STAFF REPORT

CASE NUMBER: P. D. 08-312 CC **L.U.C.B. MEETING:** June 12, 2008

DEVELOPMENT NAME: SHELBY DRIVE/GERMANTOWN ROAD PLANNED DEVELOPMENT, 3RD AMENDMENT

REQUEST: Planned development amendment to allow a Community Recreation Center

PRELIMINARY SITE PLAN
COMMUNITY RECREATION CENTER
MEMPHIS, TENNESSEE
TOTAL AREA: 6.42 AC.
WARD 002, BLOCK 55, & PARCEL No. 00674
No. OF LOTS: 1
100 YEAR FLOOD ELEV.: N/A
DEVELOPED BY:
MICKELL LOWERY
2035 MONTREAU DRIVE
MEMPHIS, TENNESSEE 38134

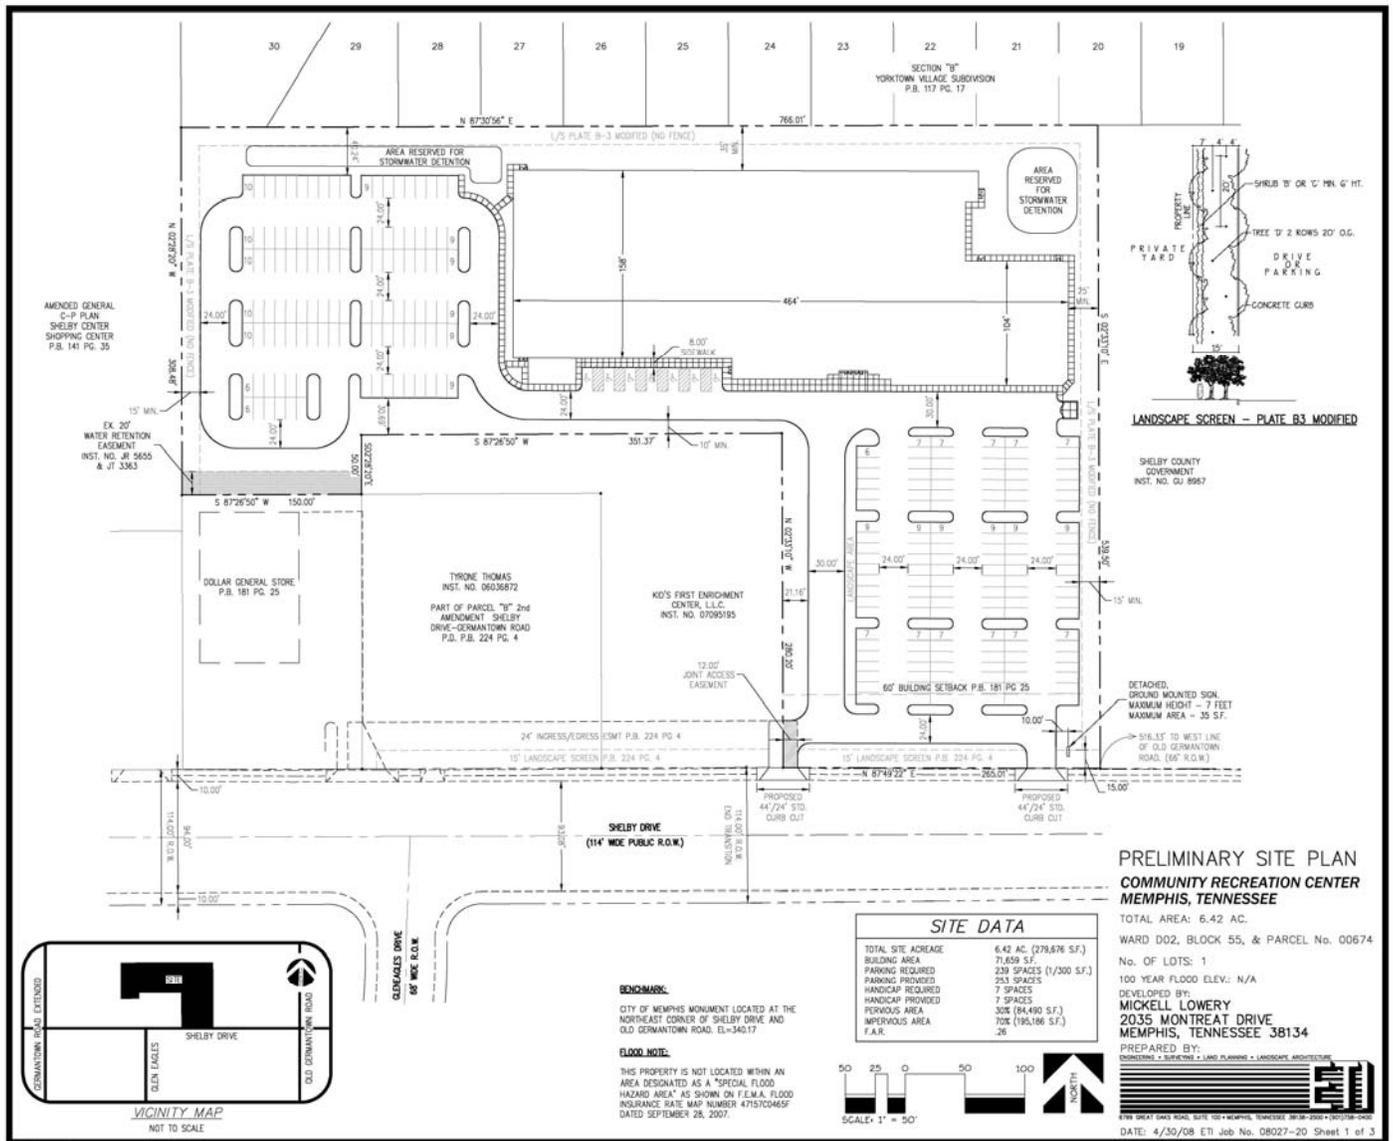
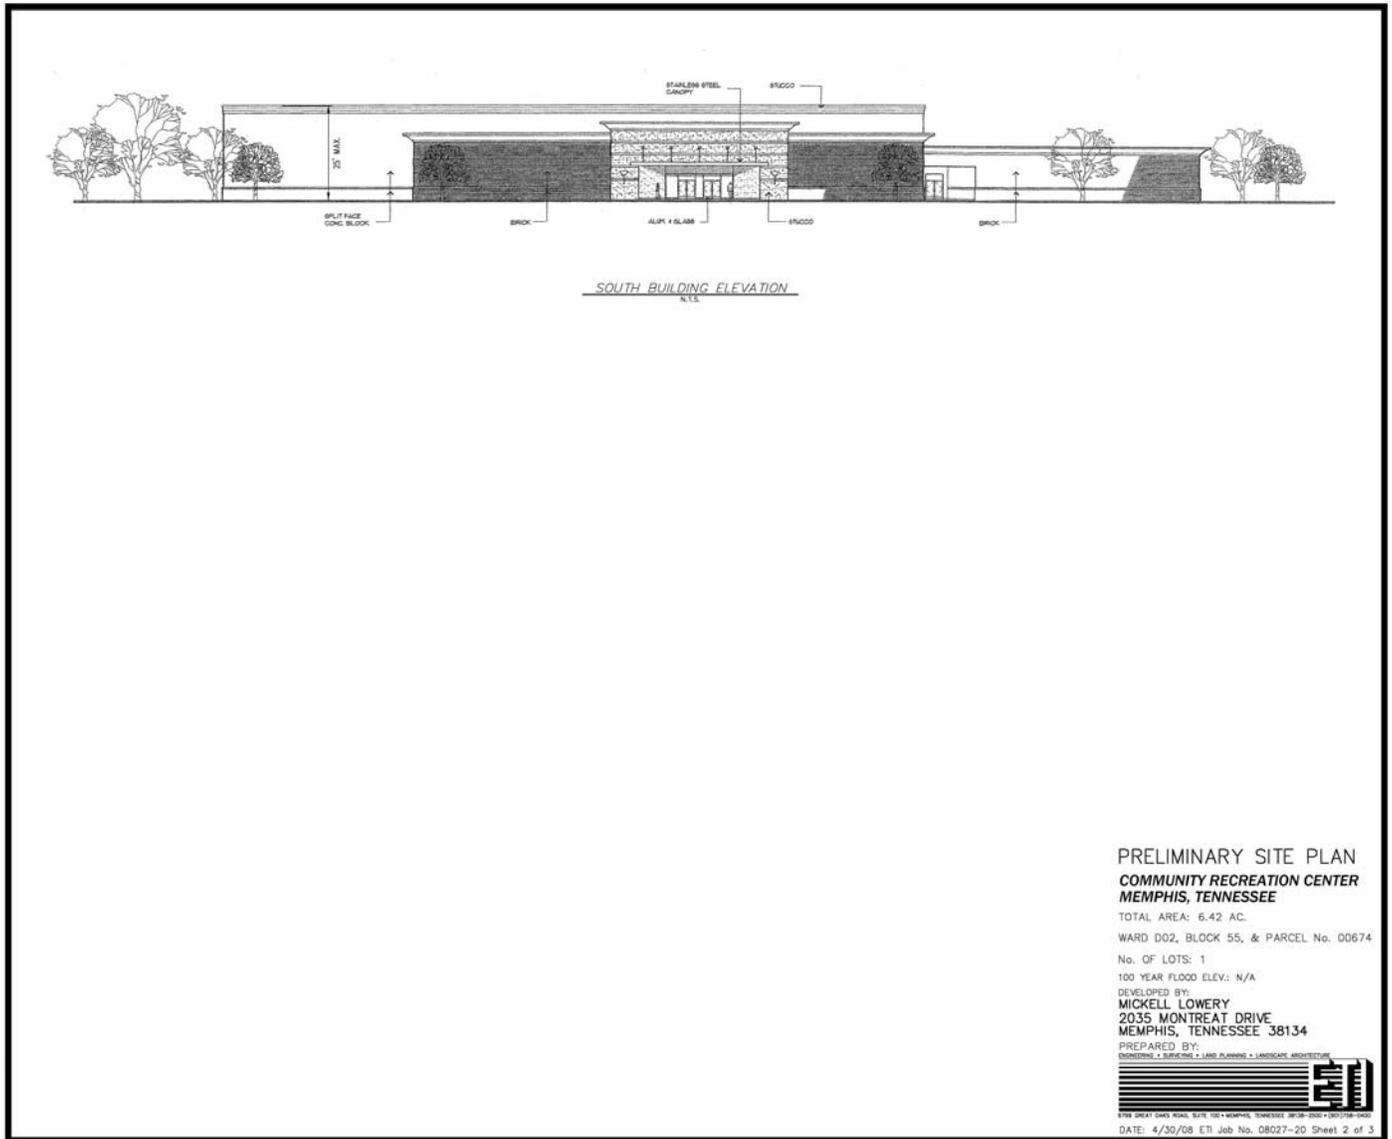
- 5. The site plan does not take into consideration internal circulation requirements to the balance of the property. This amendment is supported with internal circulation provided as required by the approved Concept Plan.**

A community recreation center land use at this location is appropriate, but careful consideration should be given to the north property line adjacent to single family homes. This amendment seeks to place the building to the rear of the parcel at a greater setback from the street and thirty-five(35') feet from single family homes in Yorktown Village Subdivision. The mature trees and vegetation along this north property line shall be preserved and maintained and not disturbed as illustrated on the Landscape Plan.

This land use at this location can be supported, because existing and proposed land uses are compatible to a recreation center with indoor sports activities. The land use complements an area with no such facility and the large assembly land uses for churches as well as residential neighborhoods. The applicant's site plan reflects a 71,659 sq. ft. building setback 314 feet from the street with parking and drive aisles at the front entrance. The site plan does not take into consideration internal circulation requirements to the balance of the property. This amendment is supported with internal circulation provided as required by the approved Concept Plan.

D. A Community Recreation Center shall be permitted in Parcels 'A', 'B' & 'C'.

B. The Community Recreation Center shall have a maximum Floor Area Ratio as shown on the Outline Plan

- B. Existing vegetation shall be preserved along the northern property line and supplemented with Evergreen trees and shrubs subject to approval by the Office of Planning and Development.

K. *A detailed 'Landscape Plan' shall be included in the final plan of development for the Community Recreation Center illustrating plant materials and an 'Undisturbed Natural Buffer' along the north property line.*
